08 October 2019

Springvale Water Treatment Project Modification 1 Response to Submissions

Figure 2-1 Thompsons Creek Reservoir spill probability

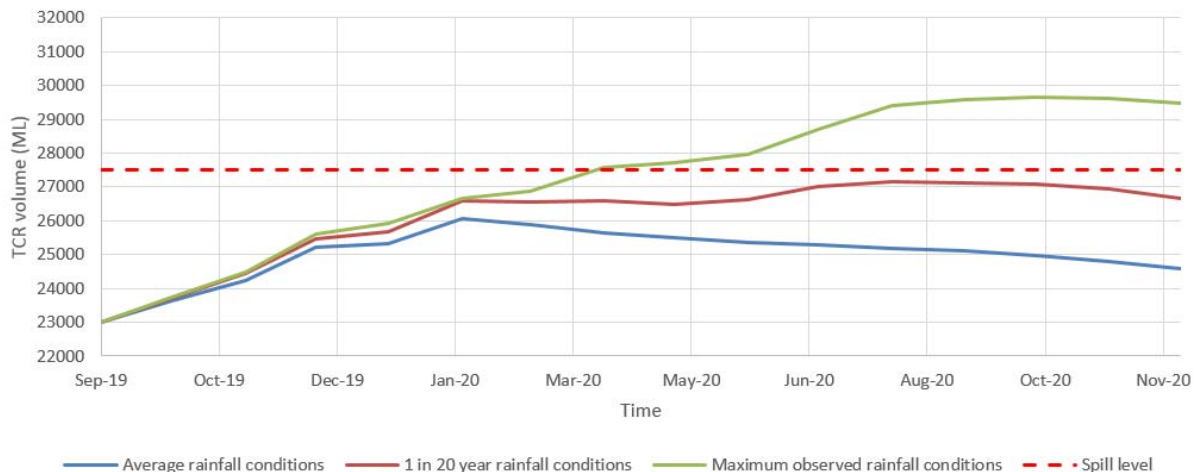
The EPA queried the environmental assessment which indicated that overflows were not predicted to occur during the implementation of the Interim Water Management Strategy, based upon the relationship between water use and power supply and the current restrictions in power generation due to coal supply issues. EPA notes that Energy Australia's Environment Protection Licence (EPL) 13007 does not include a licenced discharge point downstream from Thompsons Creek Reservoir and that traditionally water within the reservoir had been equivalent in chemical composition to the downstream receiving environment. Concerns were raised that changes in water quality as a result of the proposed modification are increasing to a level that is different from Pipers Flat Creek.

1. Develop a contingency strategy to account for potential changes in water volumes at Thompsons Creek Reservoir as a result of its current reduced operations
2. Investigates the requirement for a discharge point on EPL 13007 to authorise discharge of water from Thompsons Creek Reservoir that will have an increased EC and altered pH and phosphate concentrations.

The results of the revised modelling are presented in Figure 2-1.

The modelling indicates that spilling or additional flow releases from Thompsons Creek Reservoir will not be required during the period of extended operation of the Interim Water Management Strategy to 31st of January 2020. Following this period, the potential for additional flow releases would only be required if maximum observed historical rainfall conditions persisted throughout the modelled period. Spilling is not predicted under either average or 1 in 20 wet year rainfall conditions and with current climate predictions

expecting continued drier than average conditions the risk of spilling in the medium term is considered to be very low.

Figure 2-2 EC Levels in 800 Panel Area (Source: Centennial Coal)

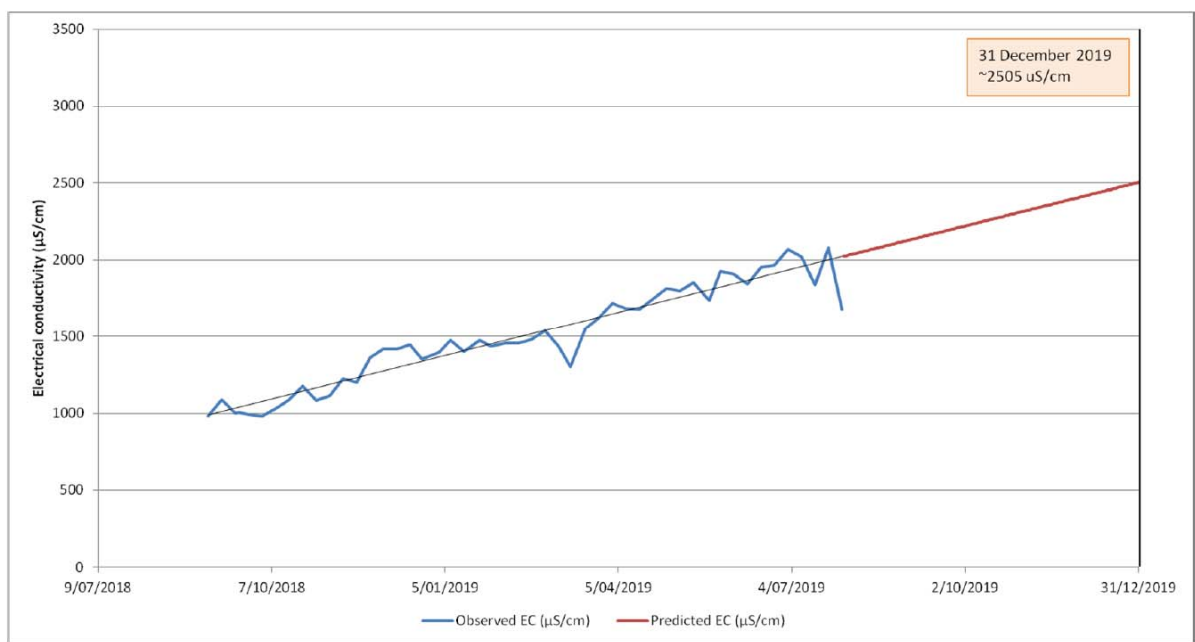
The EPA also note that the transfer volume increase from 24 ML/day to 36 ML/day coincides with the cessation in use of the temporary desalination system at Angus Place Mine. While the Angus Place desalination system was recognised as not being a viable long term solution, further justification for the increase in transfer volume was not provided given the time period of one month.

The EPA submission notes that the transfer volume increase from 24 ML/day to 36 ML/day coincides with the cessation in use of the temporary desalination system at Angus Place Mine and that further justification for the increase in transfer volume is required given the limited time period of one month.

- 10th May 2019 – 1855 $\mu\text{S}/\text{cm}$ (EC known from monitoring).
- 30th June 2019 – 1968 $\mu\text{S}/\text{cm}$ (EC known from monitoring).
- 30th December 2019 – 2505 $\mu\text{S}/\text{cm}$ (EC predicted based on linear trend outline in Figure 2-2)

The projected linear trend for EC within the 800 panel area is predicting an increase in EC to around 2505 µS/cm, which results in combined water transfers not being able to meet the EC limit of <1300 µS/cm required for normal operation of the plant. Any further increase in the EC of incoming mine water to the Springvale water treatment facility will compromise the potential to effectively treat mine water into the future and is not considered a viable option even for a limited period of one month.
